**Responses to Request for Additional Information
Certificate of Compliance No. 1032
Docket No. 72-1032
HI-STORM FW Storage System
Amendment No. 6**

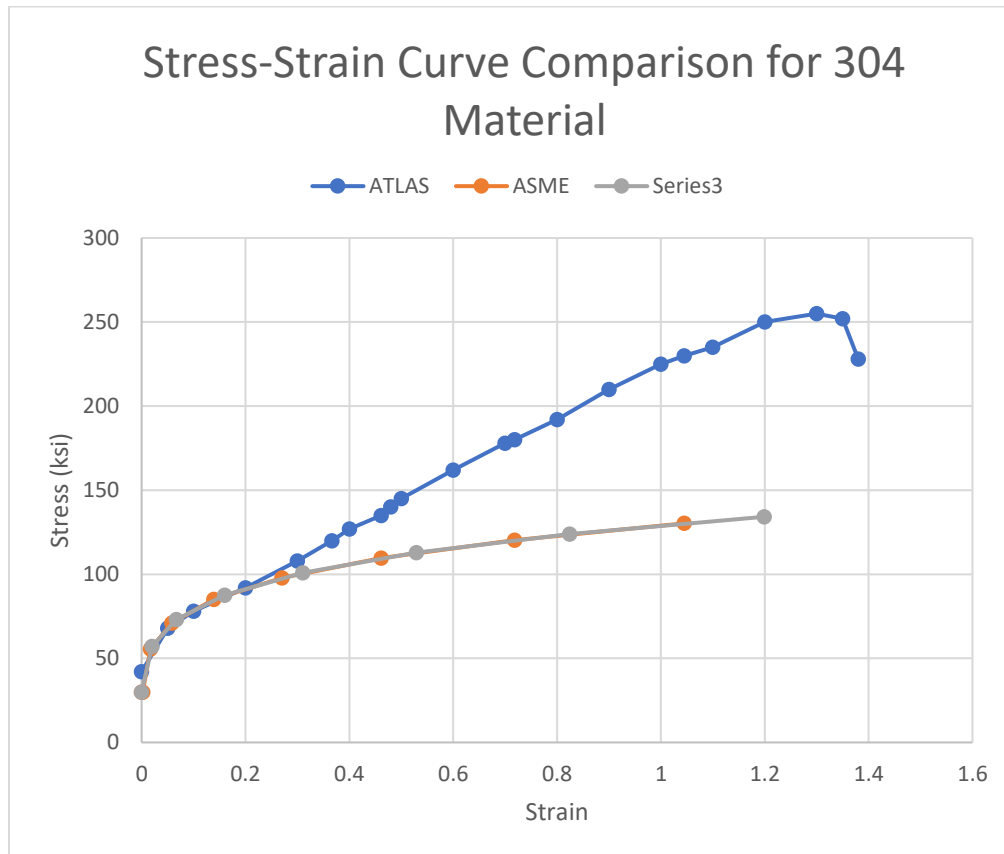
- a) mechanical property data based on physical testing for the materials evaluated using a strain-based approach for the drop accident conditions presented in Holtec Report HI-2200647;
- b) failure strains and material flow curves based on this physical testing that consider strain-rate effects, uniform elongation, and triaxiality effects for use in the finite element analysis and structural evaluation of the drop accident conditions presented in Holtec Report HI-2200647; and
- c) an updated finite element analysis and structural evaluation of the drop accident conditions presented in Holtec Report HI-2200647 using failure strains and material flow curves based on mechanical property data obtained from physical testing.

The methodology used in Appendix B to Holtec Report HI-2200647 to compute material flow curves for the finite element structural analysis and strain-based evaluations follows the Holtec Position Paper DS-307, "Construction of True-Stress-True-Strain Curves for LS-DYNA Simulations." The staff notes that the use of the methodology outlined in this position paper has previously been found inadequate to provide material data for strain-based evaluations, in particular for an evaluation of the ATB 1T transportation package. Specifically, constants used to develop material flow curves have been determined analytically (e.g., constants "K" and "n") without the support of material testing. As discussed in the summary of the November 13, 2018, meeting with Holtec International (ADAMS Accession No. ML18331A184), the staff's position is that these constants should be based on mean test values obtained from material testing. In addition, the applicant needs to supply material flow curves that consider strain-rate effects, uniform elongation, and triaxiality effects if the material is challenged beyond the uniform elongation limit.

The constants used to develop material flow curves (e.g., constants “ K ” and “ n ”) are not arbitrary “guessed” values. The values of K and n are computed using an iterative solution method implemented in Mathcad to find the converged solution, which requires an initial guess value. The final converged values of K and n are mathematically accurate and consistent with the underlying material properties (i.e., S_y , S_u , elongation, % reduction of area). See the response to RAI 5-21 from HI-STORE application (Docket # 72-1051) for more detailed information (which was recently submitted on November 20, 2020).

The following figure show the comparison between the material flow curves for a typical stainless-steel 304 material using 2 distinct approaches, as follows:

- a. ASME minimum strength properties
- b. Atlas-stress and strain curves [Ref-2]

It is clearly noted that the curve developed using the ASME minimum properties, which is the basis for the licensing analysis in support of this amendment, is lower than the curve obtained from the other two sources.

Cross-Section of Anchorage at Location of Anchor Stud

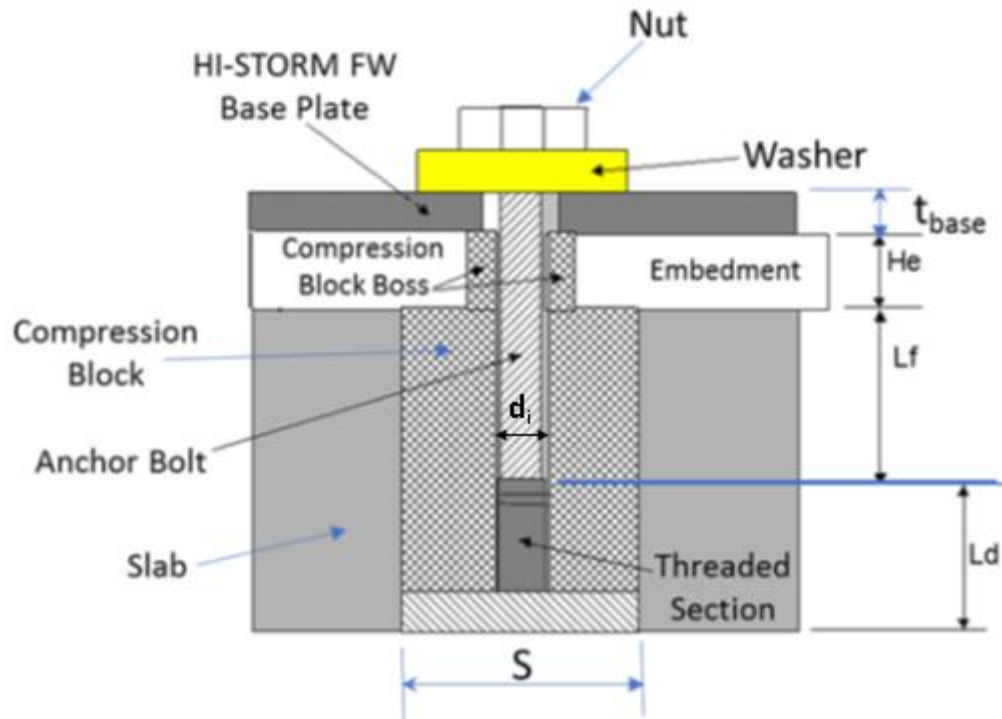
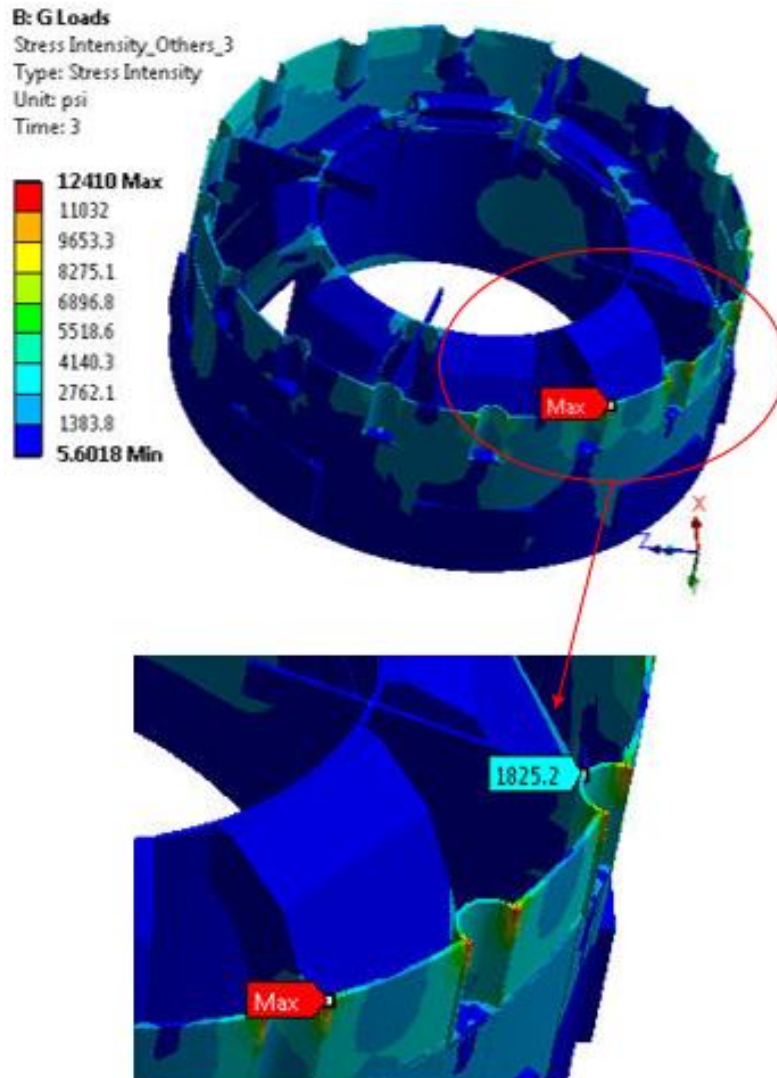
Clarify the discrepancy between the depictions of the anchorage for the HI-STORM FW, Version E, in Drawing No. 11695, "HI-STORM FW Version E Anchored Cask," and Holtec Report HI-2188720, "Structural Calculation Package for HI-STORM FW Anchor System" and revise the SAR, drawings, and calculations as necessary.

The structural evaluation of the anchored HI-STORM FW system relies on finite element analysis and hand calculations presented in Holtec Report HI-2188720. However, the anchorage configuration evaluated in Holtec Report HI-2188720 differs from the anchorage configuration depicted in the drawings and SAR description of the HI-STORM FW anchorage. Specifically, the anchorage evaluated in Holtec Report HI-2188720 is comprised of several anchorage components that are not depicted in the SAR Drawings, such as an embedment plate, compression block, and anchor rod. As this anchorage hardware is designated as ITS and relied on to resist accident loads (e.g., loads associated with the earthquake and tornado accident conditions), the staff requests clarification of the components and configuration of the anchorage hardware and that the SAR, drawings, and calculations be updated as necessary.

The details of the anchorage system are added in the FSAR, Section 3.1. A figure depicting the typical anchorage system of the HI-STORM FW, Version E is also added in Section 3.1 of the FSAR. The same figure is reproduced below. All the critical dimensions of the anchorage system critical components are also presented in Table 3.1.15 of the FSAR. The embedment details are provided in the Figure 3.1.1 and Table 3.1.15 of the SAR. Any site-specific modifications or deviations from this concept will be evaluated as deemed appropriate for determining the safety consequence.
